MEMORANDUM

Date: 10 MAR 2016
To: Planning Commission
RE: S15-09-III / Standard at Morgantown LLC / 1303 University Avenue
Matters raised during the Planning Commission's 10 DEC 2016 hearing

Subject: Review of TIS for "The Standard"

RE: University Avenue Pedestrian Bridge

FIGURE	10
D.B. MJY C.B. MDS REV.

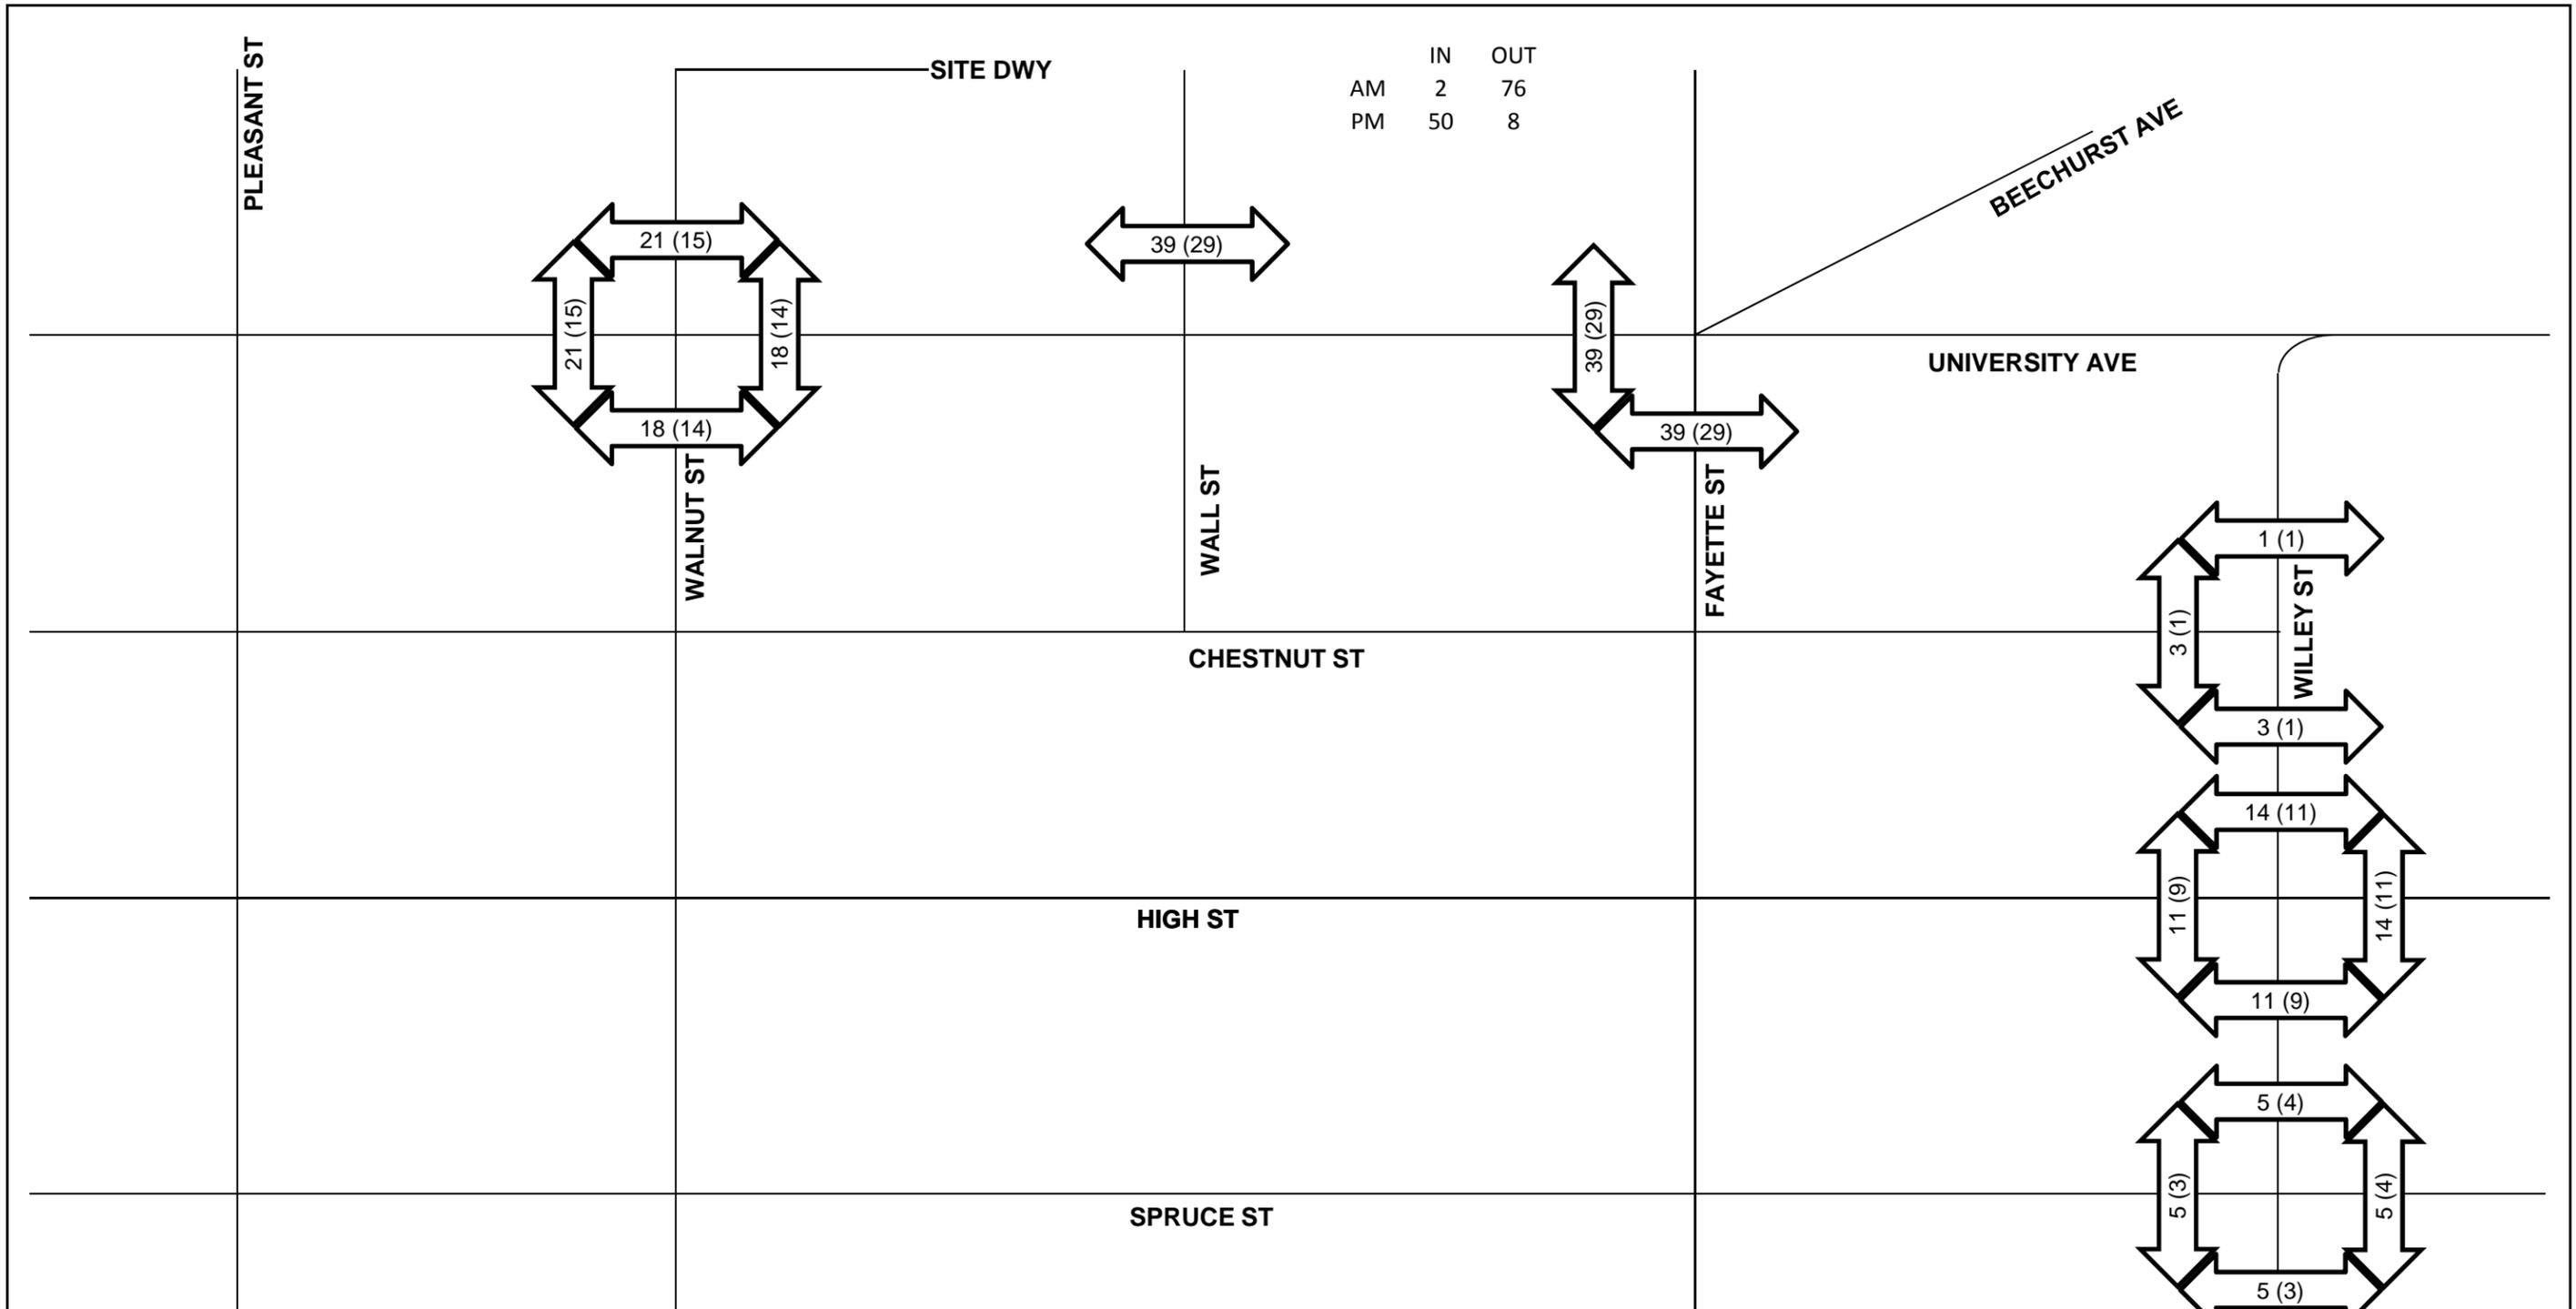
7. What is the traffic solution as a result of this development? There needs to be an official opinion from the City Engineer as well as a summary of pedestrian movements across the street and how many minutes delay there will be during rush hour as a result of the street being blocked by pedestrian crossing?

The DOH agreed with this methodology. The projected number of pedestrian trips generated by the development was 82 during the AM peak hour and 61 during the PM peak hour. The pedestrian trips were distributed through the study intersections based on principal destinations such as the WVU Downtown campus and the PRT station. The AM and PM peak hour pedestrian trips are presented in Figure 10 in the TIS which is attached to this memo. As shown on the figure, approximately one-half of the pedestrian trips were routed to the PRT station and one-half were routed to the WVU Downtown campus. These trips were added to existing pedestrians counted by TA.

A capacity analysis of the study intersections was performed without and with the additional pedestrian and vehicular trips generated by the development. The results of that analysis concluded that even with the additional pedestrians and vehicles generated by the development, minimal increases in overall delay were incurred to vehicular traffic at the study intersections.

Based on TA's analysis, the additional pedestrian traffic generated by the development can be accommodated at the study intersections without mitigation beyond that already recommended in the TIS.
